Engineering Change Notification

NHD-7.0-1024600AF-LSXP
NHD-7.0-1024600AF-LSXP-CTP
NHD-7.0-1024600AF-LSXP-CTPIM

NHD-7.0-HDMI-HR-RSXP
NHD-7.0-HDMI-HR-RSXP-CTU

Old Design	New Design

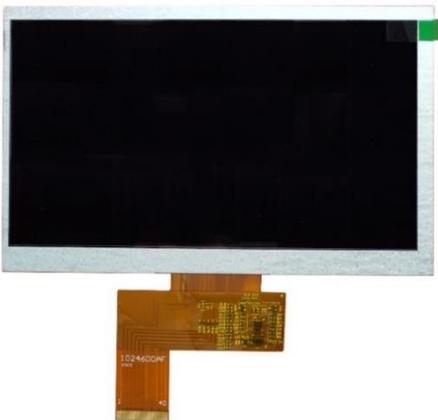
The display FPC has been redesigned to add EMI shielding for better EMC. The new FPC cable is also less susceptible to nicks and tears.

The new version does not require a change to the user's software or hardware design. The FPC size, shape and 40pin connection for the user remain unchanged.

The new displays will be labeled with a different revision control number after the part number. See example below.
